# 11TH AND REPUBLICAN

## EARLY DESIGN GUIDANCE 2 DPD #3012300

**ADDRESS:** 505 11th Avenue E  
**DPD PROJECT #:** 3012300  
**OWNER:** nic|chick llc  
**APPLICANT:** Nicholson Kovalchick Architects PS  
**CONTACT:** Alyssa Mehl, LEED AP BD+C  
 4302 SW Alaska St. Ste. 200;  
 Seattle, WA 98116;  
 206.933.1150

**A-2; A-5: NEIGHBORHOOD STREET PATTERN**

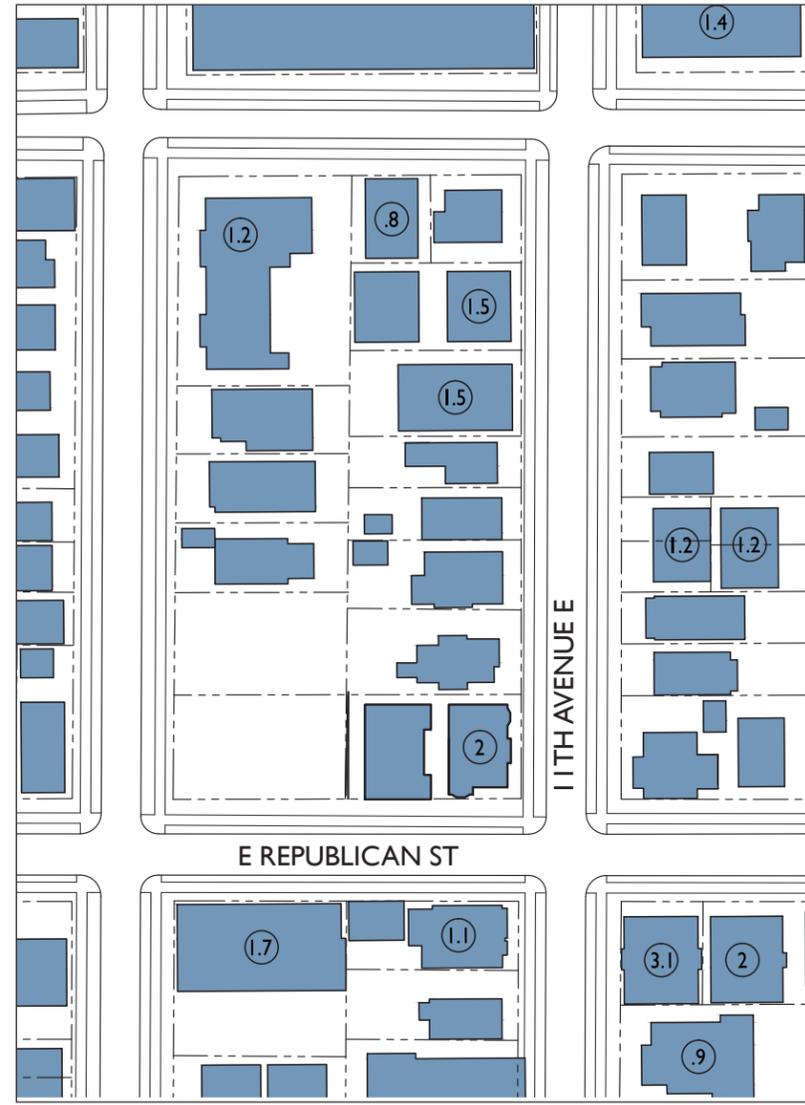
A-2	Streetscape Compatibility	<ul style="list-style-type: none"> <li>The Board requested that the design reflect the rhythm along 11th Avenue through large massing breaks at the north and south property lines; however, it was noted that a departure from the east setback may be justifiable.</li> <li>One suggestion was to place the existing structure at the east property line, but not add new structures to the north or south of it.</li> <li>It was further noted that it is also possible to achieve this by demolishing the existing structures and building new structures to respond to this street pattern.</li> </ul>	<ul style="list-style-type: none"> <li>The required 5'-0" north setback is maintained to reflect the rhythm along 11th Avenue.</li> <li>The existing house is relocated adjacent to the east property line and an addition is connected to the north of the existing house. The character and massing of the addition merges with the existing house, so as to maintain the rhythm along 11th Avenue. This pattern is shown on the adjacent page.</li> </ul>	<ul style="list-style-type: none"> <li>The existing house is demolished and the north, south, east, and west setback requirements are maintained.</li> <li>Front stoops at the east facade of the east building respond to the rhythm along 11th Avenue.</li> </ul>

A-5	Respect for Adjacent Sites	<ul style="list-style-type: none"> <li>The Board requested that the building mass meet the setback requirements at the west and north property lines. These setback requirements are a 15'-0" west (rear yard) setback and a 5'-0" north (side yard) setback.</li> <li>The Board stated that departures from the east property line (front yard) setback, the south property line (side yard) setback, and the internal setbacks between buildings could be considered.</li> <li>The Board stated that the proposed building at the north property line per EDG I Option 4 disrupts the pattern of streetscape at 11th Avenue.</li> <li>The Board requested that the proposed development design respond to the activities anticipated at the Park and the needs for privacy for residents to the north.</li> <li>The Board requested shadow studies of the proposed massing shadows on the Park and the property line to the north.</li> </ul>	<ul style="list-style-type: none"> <li>The setback requirement at the north property line is maintained per the Board request.</li> <li>In order to maintain the development potential of the site and to justify the cost of renovating the existing house to remain on-site, the new development must include a required amount of rentable square footage and FAR. Therefore, departures into the west, east, and south property line setbacks are requested to create a mix of apartment units and types that are sufficiently dimensioned.</li> <li>The proposed stand-alone building at the north property line in EDG I Option 4 is eliminated. A new addition is proposed to be connected to the north side of the original footprint of the existing house. This addition will match the character of the existing house and it fits within the required north property line setback.</li> <li>The west facade steps back 5-8 feet at the top floor in order to accommodate the needs of the park. Windows and views are oriented toward the west, south, and east in order to maintain the privacy of the neighbors to the north.</li> <li>See pages 10-13 for shadow studies, per the Board request.</li> </ul>	<ul style="list-style-type: none"> <li>All property line setback requirements are maintained.</li> <li>The west building is 1/2 story lower than the east building in to reduce the height and bulk of the building adjacent to the Park per the Board recommendation.</li> <li>Windows and views are oriented toward the west, south, and east in order to maintain the privacy of the neighbors to the north.</li> <li>See pages 10-13 for shadow studies, per the Board request.</li> </ul>

**A-1; A-8; D-3: RETAINING WALL**

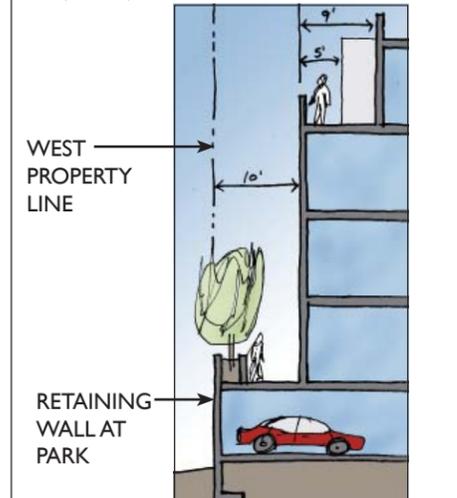
D-3	Retaining Walls	<ul style="list-style-type: none"> <li>The Board requested more information about the retaining wall at the west property line. The retaining wall should be designed in context with the Park uses and provide a good transition between the Park and the proposed development.</li> </ul>	<ul style="list-style-type: none"> <li>See response to A-1. See diagram on page 9.</li> </ul>

It is the preferred option for the Park design to utilize the retaining wall at the west property line of the proposed site. The west side of this retaining wall can be given to the park to use as a "Front Porch". The wall is proposed to be combined with the parking garage structure of the proposed development.

**A-1; A-5; A-8; B-1: OPTION A - STEP-BACK AT WEST FACADE**

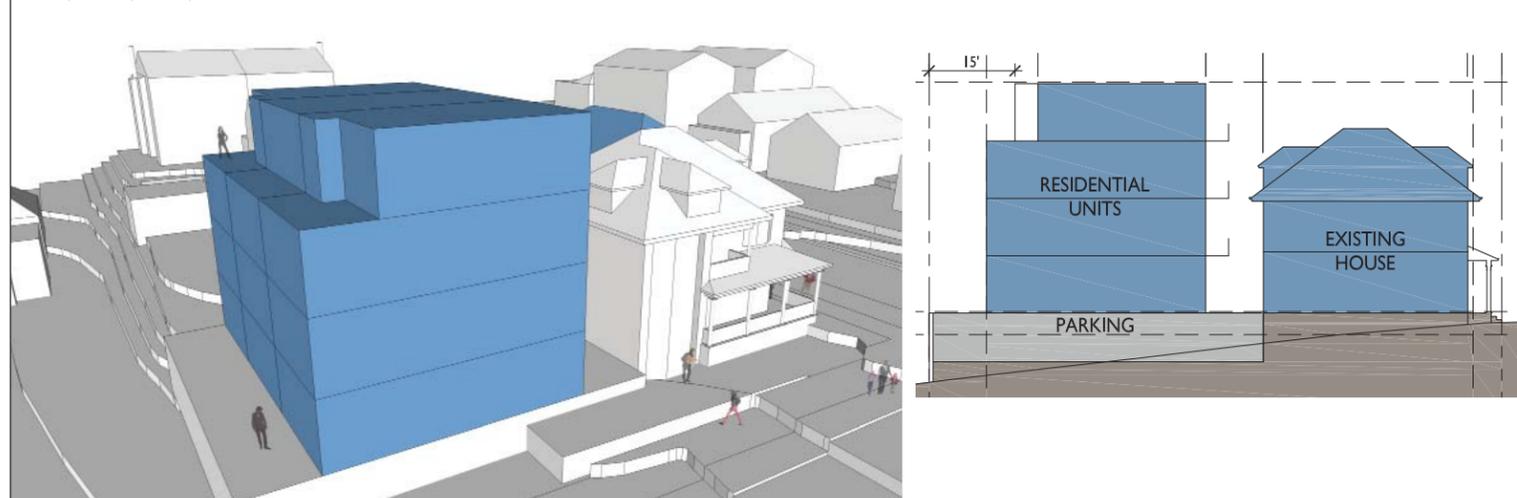
DESIGN GUIDELINE	DRB REQUEST AT EDG I MEETING	RESPONSE TO DRB REQUEST: OPTION A	RESPONSE TO DRB REQUEST: OPTION B
A-1	Responding to Site Characteristics	<ul style="list-style-type: none"> <li>In order to reduce the height and bulk of the proposed building at the west edge and the southwest corner of the site, the Board requested the removal of below grade parking.</li> </ul>	<ul style="list-style-type: none"> <li>The public expressed concern for the existing lack of parking that is available along the adjacent streets. Ten below-grade parking stalls are included in the project to accommodate the request for more parking. The west wall of the below grade parking structure is proposed to be used for the wall at the Park, per the request of the current Park design.</li> </ul>	<ul style="list-style-type: none"> <li>This option also ten below-grade parking stalls per the reasons noted in Option A.</li> <li>The parking garage is located under the east building. The west building is 1/2 story lower than the east building in to reduce the height and bulk of the building adjacent to the Park per the Board recommendation. See Option B Section.</li> </ul>

B-1	Height, Bulk, and Scale Compatibility	<ul style="list-style-type: none"> <li>The Board requested the new building to be dropped one story through the elimination of below grade parking.</li> <li>The Board also requested stepping the building back at the west facade to maximize light and air at the Park; and responding to the context of the Park, the 11th Ave streetscape, and the grade changes on site.</li> </ul>	<ul style="list-style-type: none"> <li>See response to A-1.</li> <li>The new building at the west property line does include a 5'-0" to 8'-0" setback in order to maximize light and air toward the Park, per the request of the Board.</li> </ul>	<ul style="list-style-type: none"> <li>See response to A-1.</li> <li>Per the response to A-1, the parking garage is located to the east of the site and the west building is 1/2 of a story lower than the east building to allow for maximum light and air on the park.</li> </ul>
